Subject: MHI's Response to US-APWR DCD RAI No.539-4329 Revision 2

References: 1) "Request for Additional Information No.539-4329 Revision 2, SRP Section: 09.04.02 – Spent Fuel Pool Area Ventilation System, Application Section: DCD 9.4.2 & 9.4.3" dated March 2, 2010.

Response to Request for Additional Information
No. 539-4329, Revision 2

RAI NO.: NO.539-4329 REVISION 2
SRP SECTION: 09.04.02 – SPENT FUEL POOL AREA VENTILATION SYSTEM
APPLICATION SECTION: Tier 2 DCD FSAR Sections 9.4.2 & 9.4.3
DATE OF RAI ISSUE: 03/02/2010

Figure 9.4.3-1 Auxiliary Building HVAC System Flow Diagram (Markup)

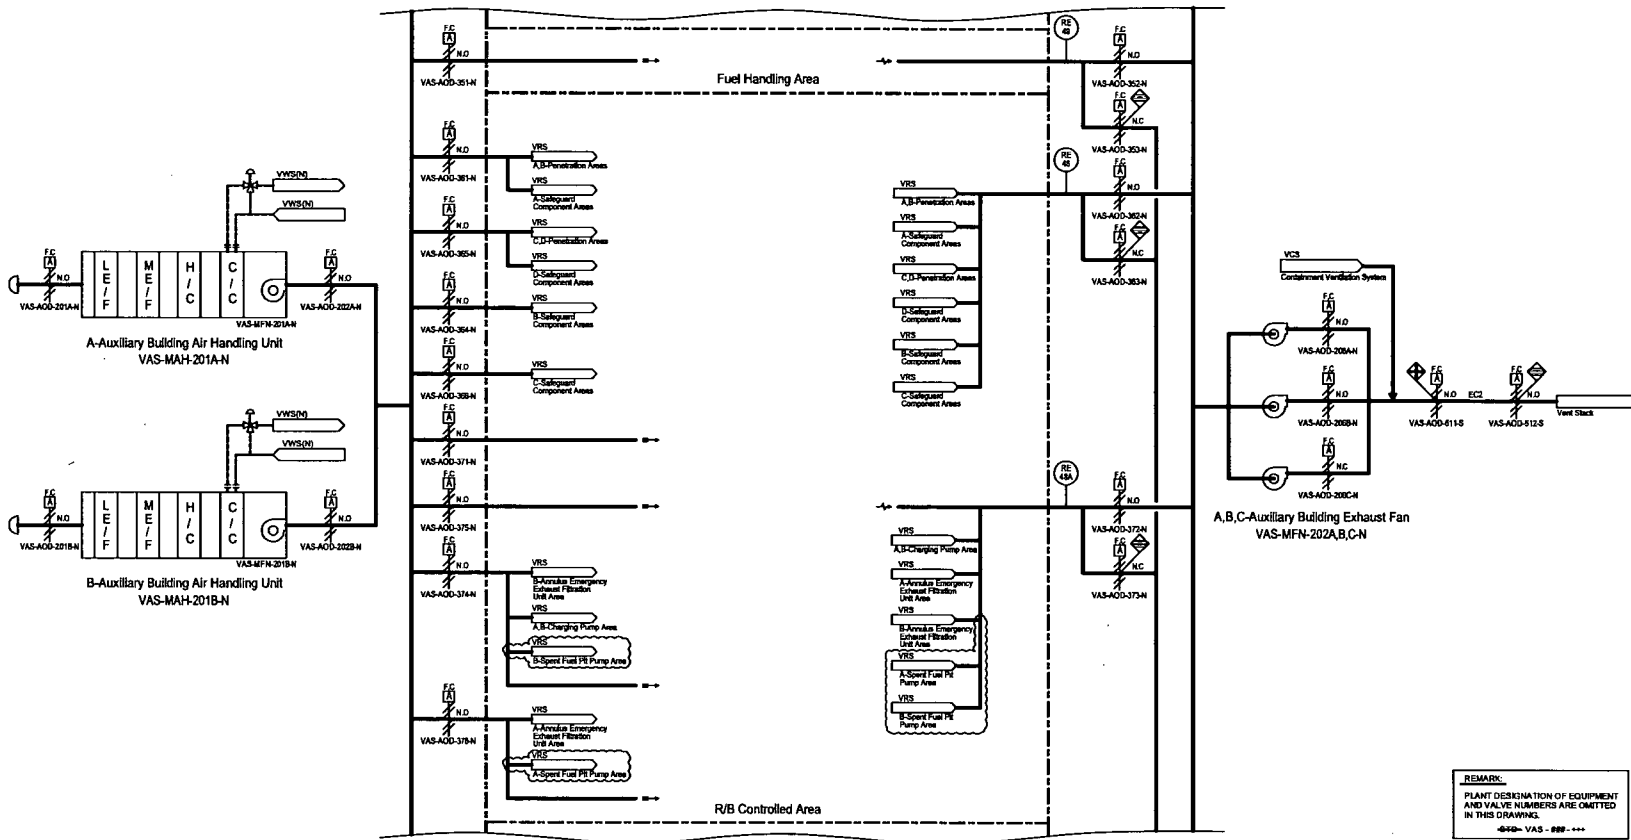
1) Figure 9.4.3-1 has not been revised to reflect that the SFP Pump and HX rooms, as displayed in Figures 1.2-16 and 1.2-24, are not part of the "fuel handling area." These areas are part of the R/B controlled area and are serviced by the A/B HVAC system during normal mode of operation. The R/B controlled area as displayed on this figure should be revised to reflect the existence of the SFP Pump and HX rooms.

- 1) Figure 9.4.3-1 is revised to reflect the existence of the SFP Pump Areas.
- 2) DCD section 9.4.3.2.1 is revised to consistent with the response to RAI No.328-2436 Revision 1 Question 09.04.02-2.
- 3) The airflow rate (i.e. Zone V to VI: 1,500 cfm; Radiation Zone IV: 14,000 cfm; and Radiation Zone III : 76,000 cfm.) shown in Table 12.2-60 Sheet 3 of 3 of DCD Tier 2 Revision 2 is the minimum exhaust airflow rate from radiological controlled areas (RCA) that are served by the auxiliary building HVAC system. Thus, as-design exhaust airflow rate from RCA that is served by the auxiliary building HVAC system may be more than the airflow rate shown in Table 12.2-60 Sheet 3 of 3. Meanwhile, the supply airflow to RCA is designed to be less than the exhaust airflow rate and to maintain a slightly negative pressure in the controlled areas with respect to outdoor environment.

Figure 9.4.3-1 will be revised as shown in 4th page.
